**UPS Ford F59 Package Truck
Label and Decal Installation
ENP-737
May 27, 2020**

The Agility service team has identified certain Package Trucks built on the Ford F59 chassis, powered by the Ford V10 with Agility CNG system, that did not have all the decals and stickers installed properly prior to delivery of the units. These units will need to have the labels installed as detailed in this publication.

Figure 3: Cylinder sticker (4)

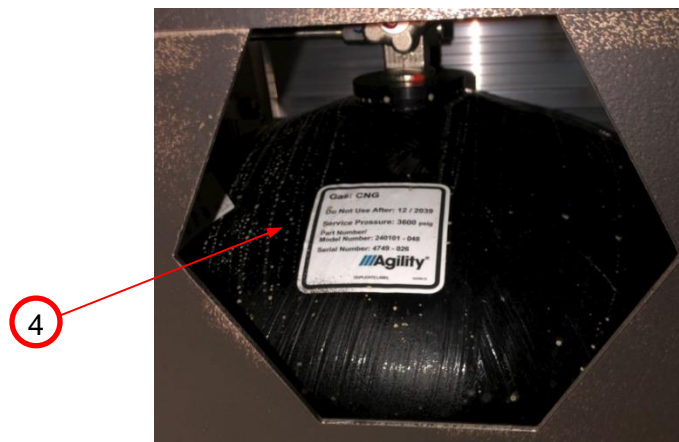
1. Using a flashlight, inspect under the unit for cylinder stickers (4) visible through the hexagonal opening in the cylinder shield.
2. If stickers are present, validate the serial number matches the stickers provided in the update kit. If stickers are not installed, wipe down cylinder with a clean rag and install sticker at the “6 o’clock” position on the tank, ensuring serial are visible through shield opening.
